**Technical Service
Information Bulletin**

Title:
**M.I.L. "ON" DTC P0031, P0051, P2238,
AND/OR P2241**

Models:
'04 – '05 ES 330

**ENGINE
EG003-05**

Calibration
Identification
Chart

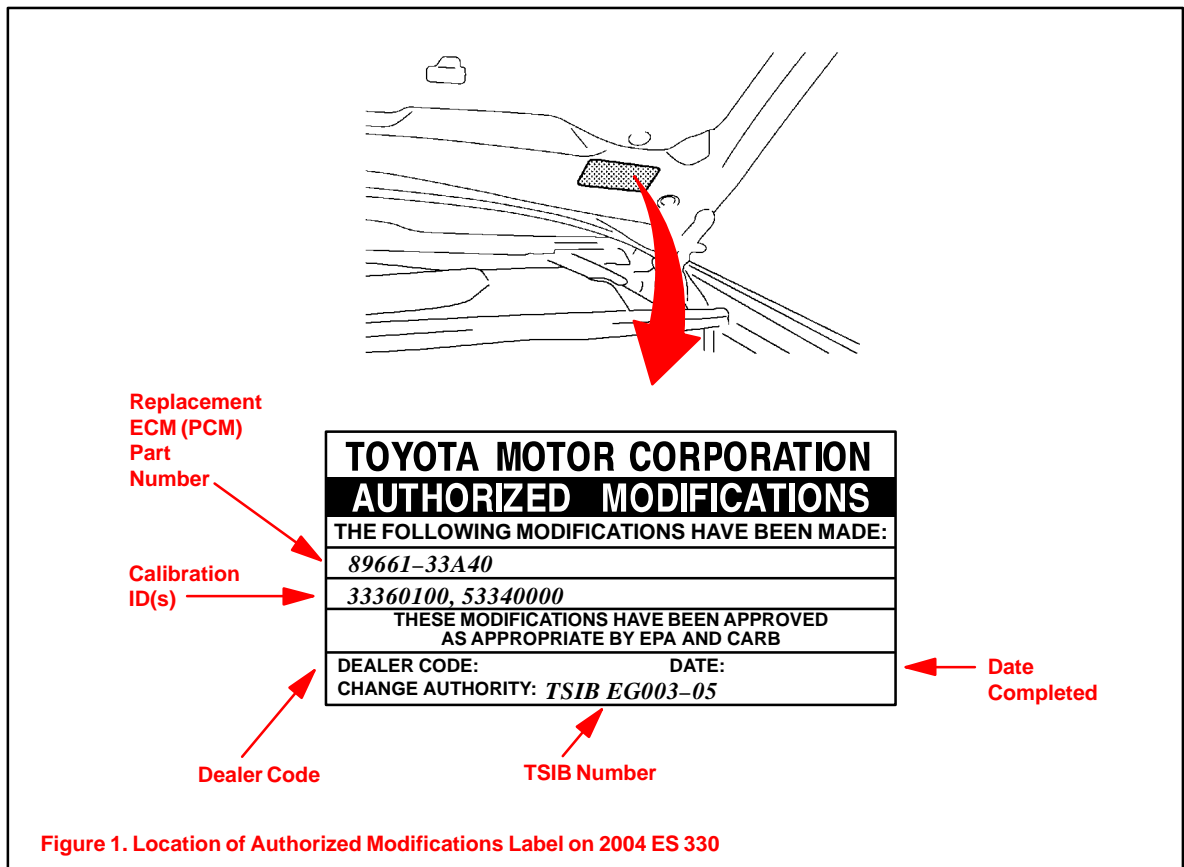
The A/F sensor manufacturing process and the Engine Control Module (ECM) (SAE term: Powertrain Control Module/PCM) logic have been modified to improve these conditions.

ENGINE	ECM (CPU)	PREVIOUS CALIBRATION ID	NEW CALIBRATION ID
3MZ-FE	Main	33350000 33350100 33360000	33360100
	Sub	53334000	53340000

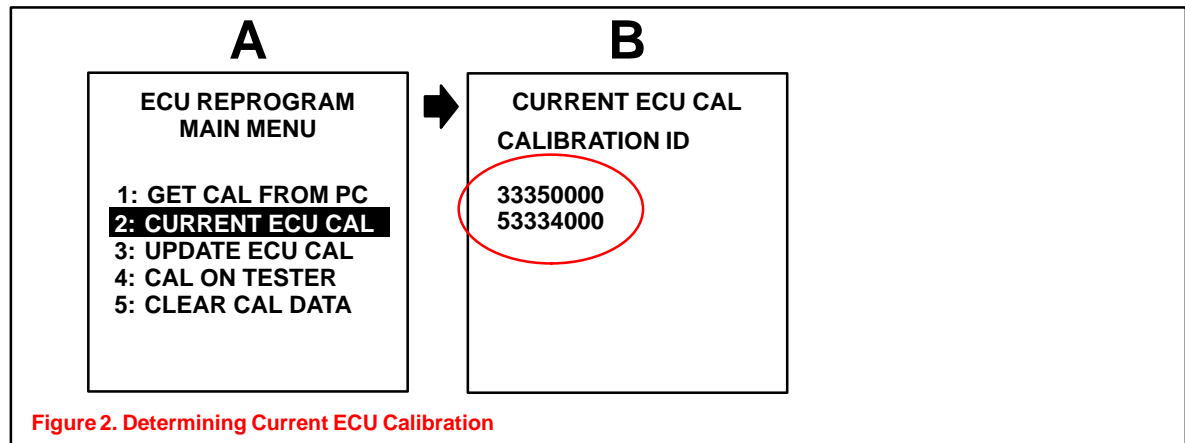
1. Replace both Bank 1, Sensor 1 and Bank 2, Sensor 1 air fuel ratio sensors.
2. Check for the Authorized Modifications Label affixed to the vehicle in the location shown in Figure 1. Confirm if ECM (PCM) calibration has been updated. If not the latest ECM (PCM) calibration — go to step 3.

3. Connect the Diagnostic Tester to the vehicle and select CURRENT ECU CAL from the ECU REPROGRAM MAIN MENU. Determine the vehicle's current ECU calibration (see Figure 2).
 - The sample screen prints seen below are the 12.01a software version and may differ from subsequent software versions.
